Fort Lauderdale Police Headquarters Project Update

June 3, 2025

CAM #25-0630 EXHIBIT 3 Page 1 of 28

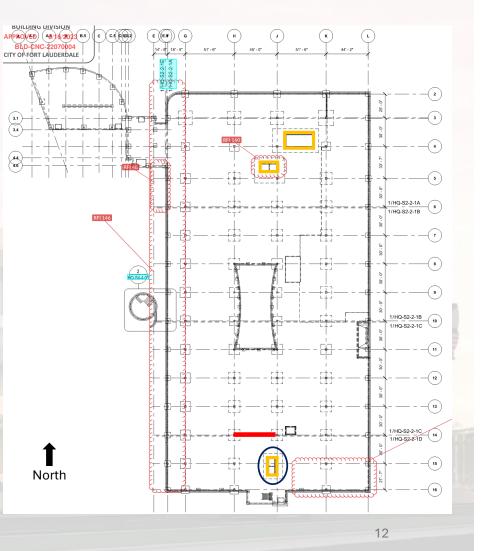
- 1. Shear Wall Capacities
 - Finding
 - The Southern-most Reinforced Concrete Core Wall is Not Code-compliant for Strength Between Levels 1 and 2
 - Possible rectification
 - Adding a Properly Designed Full-height Shear Wall (i.e., from foundation to roof) with an Accompanying Foundation on Gridline 14 Between Gridlines H and J
 - Timeframe for Rectification
 - As Soon as Possible (0 to 2 months)
 - Timeframe Set Due to Hurricane Season
 - Should be Completed Before the Building is Occupied (i.e., after construction)

2. Shear Wall Foundations

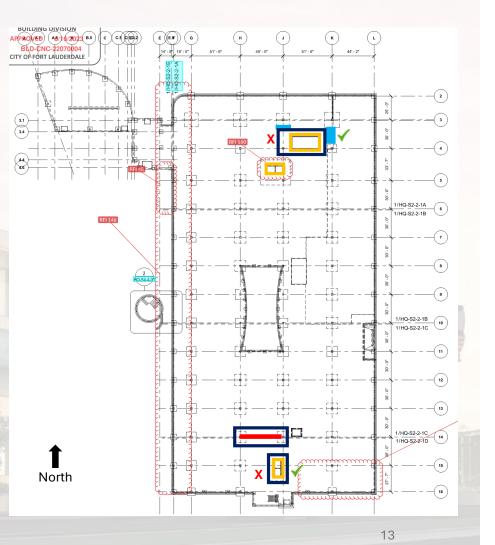
- Finding
 - The Design Capacity of the Mat Foundations for the Concrete Shear Walls Around the North Stair Shaft and the South Elevator Shaft is Exceeded Under Full Design Wind Loads and are therefore Not Code-compliant.
- Possible rectification
 - Adding the Shear Wall in Item 1 to the Building can Rectify Conditions Related to the South Elevator Shaft.
 - Attaching the Mat Footing for the North Stair Shaft to its Surrounding Isolated Spread Footings can Rectify the Sliding Capacity Condition.
- Timeframe for Rectification
 - Same as for Shear Walls

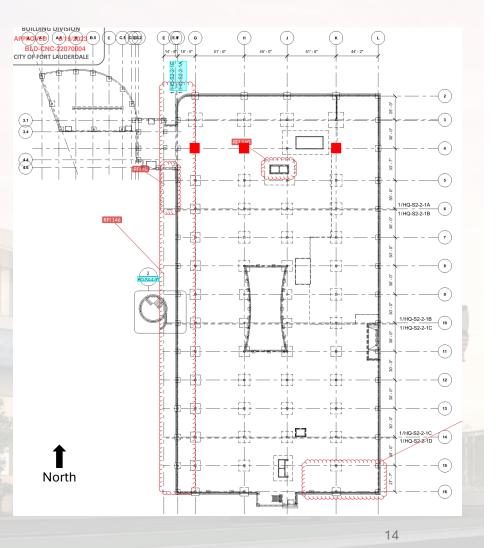
- 3. Column Foundations
 - Finding
 - Bearing Stress Under the Three Isolated Footings on Gridline 4 Exceeds the Allowable Soil Design Bearing Capacity and are Not Code-compliant.
 - Possible Rectification
 - Enlarge the Footings
 - Timeframe for Rectification
 - Before Building Occupation

AECOM/TT has informed WJE that the roof live load currently shown on the drawings (30 psf) is higher than the minimum required by code (20 psf) and will update the drawings for the lower live load. WJE can re-check the foundations with the reduced loads.

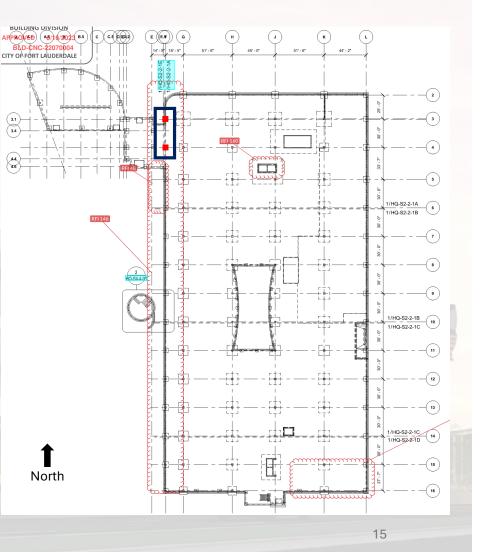
- 4. Side Bearing Capacities
 - Finding
 - Bearing Stress in the Slide Bearings on Gridline F Exceeds the Manufacturer's Published Allowable Capacity Under Full Design Loads.
 - Possible rectification
 - Replace Bearings with Higher Capacity Bearings.
 - Timeframe for Rectification
 - Before Building Occupation

AECOM/TT has acknowledged issue with slide bearings and has indicated that these bearings will be replaced with higher capacity bearings.

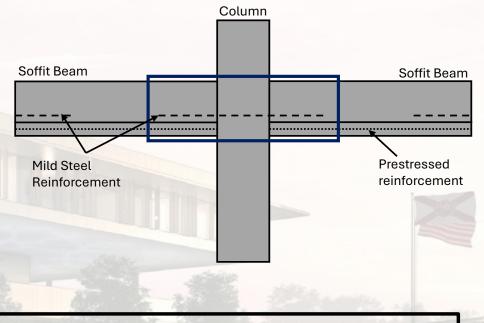
- 5. Structural Integrity Code Provisions
 - Finding
 - Detail Used to Provide Continuity of Bottom Reinforcement is Not Addressed in Appliable Building Code.
 - Note: This Building System is Widely Used within the South Florida Market.
 - Possible Rectification
 - Structural Engineer of Record to Provide Calculations, Results of Load Tests, or Other Valid Engineering Documentation which Demonstrate that this Type of Connection is Adequate to Develop Continuity of Bottom Reinforcement
 - Timeframe for Rectification
 - Before Building Occupation

Resolution of this issue is ongoing. A meeting with the Building Division of DSD, AECOM/TT, and WJE is being coordinated to discuss and resolve this issue.

6. Column Axial-Flexural Capacities

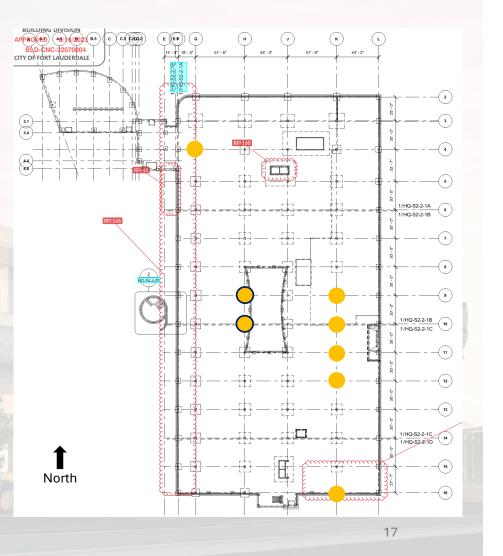
- Finding
 - Based on WJE Analysis, 24 Columns were Overstressed (under full design load) for Combined Axial and Flexural Loading and thus are Not Strictly Code-compliant. Only 8 of Those Columns were Overstressed by More Than 10%.
- Possible Rectification
 - Strengthen the Columns that are Overstressed More Than 10%
- Timeframe for Rectification
 - Before Building Occupation

AECOM/TT agrees with WJE that strengthening of the 16 columns overstressed less than 10% is not necessary. AECOM/TT and WJE will work towards a resolution on the other 8 columns.

7. Column Shear Capacities

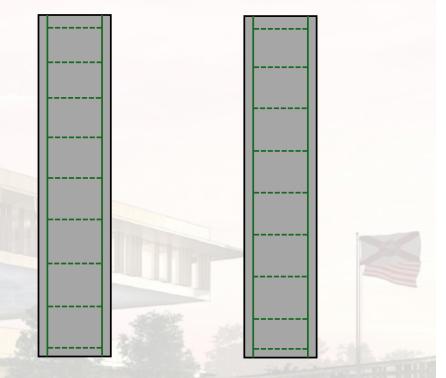
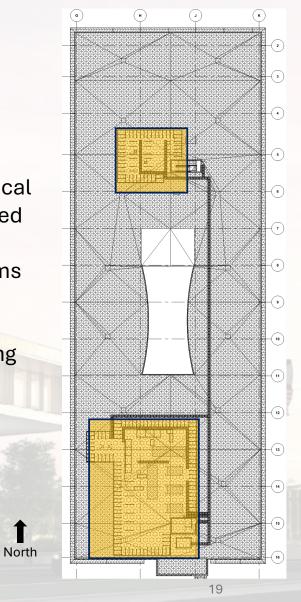
- Finding
 - Up to 50 Columns were Found Not to be Strictly Code-compliant for Shear Due to Ties Spaced more Widely than d/2.
- Possible Rectification
 - We do <u>Not</u> Believe Strengthening of these Columns is Necessary (See Graphic).
- Timeframe for Rectification
 - Before Building Occupation

ACI 318-14 requires tie spacing less than "d/2" to include strength of ties in the capacity.

d/2 ~ 10 ¾" for most 24" square columns EOR specified tie spacing of 12" maximum

AECOM/TT agrees with WJE that strengthening of these columns is not necessary.

10.Building Period

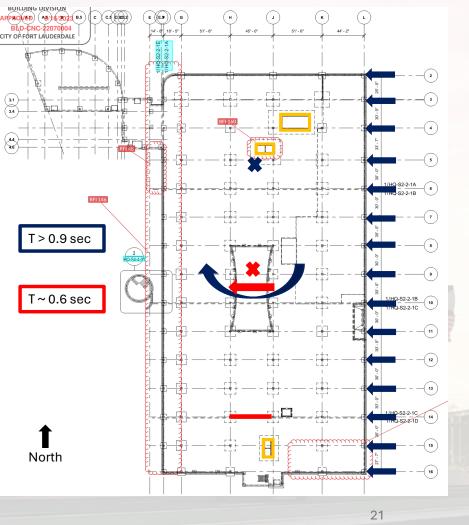
- Finding
 - Fundamental Period of Vibration (twisting mode) of the Building is Greater than 0.9 Seconds
 - Significantly Larger than Typical Concrete Shear Wall Buildings having No More than Three Stories.
 - While this Condition Does Not Violate any Code-prescribed Performance Limitations, it is Not Standard Practice to Design Structures to Perform this Way.
- Possible Rectification
 - Adding an Appropriately Designed Full-height Shear Wall to the Structure (as previously described in Item 1) Will Rectify this Condition.

11.Concrete Cover Depth

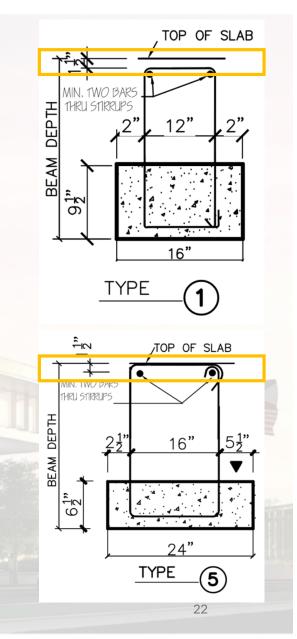
- The Precast Concrete Shop Drawings Inconsistently Indicate the Amount of Cover Depth Provided in the Soffit Beams. In Some Cases, the Cover Depth is Indicated to Satisfy Minimum Code Cover Requirements, and in Others it Does Not.
- Required Response
 - The Structural Engineer of Record Should Confirm and Document which Cover Depth was Used in the Design of the Soffit Beams.
 - If Cover Depth is Not Sufficient, Rectifications May be Required.

AECOM/TT is working on gathering documentation to show that the appropriate cover depth was maintained during construction.

12.Column Schedule

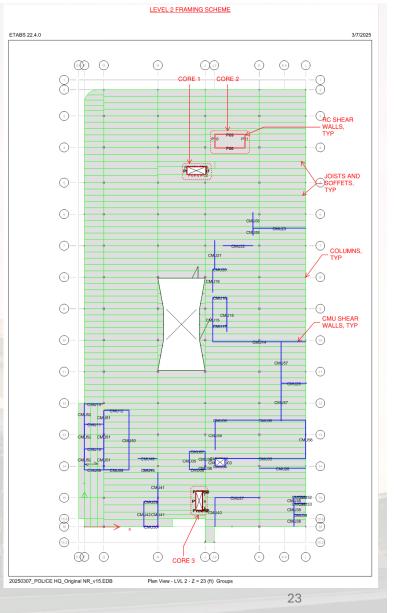
• Update Drawings

- Update Drawings
- 14.Mechanical Equipment Loads
 - Update Drawings
- 15. Masonry Walls (CMU Partitions)
- Recommended Concrete Shear Wall and Foundation Rectifications (items 1 and 2) will Address This Item.
 16.Column Flexural Stiffness Modifiers
 - It is Not Necessary for the Structural Engineer of Record to Respond <u>if</u> Recommendations made by WJE in Items 1 – 7 are

Accepted AECOM/TT is planning to update drawings, as necessary, to address Items 12-14.
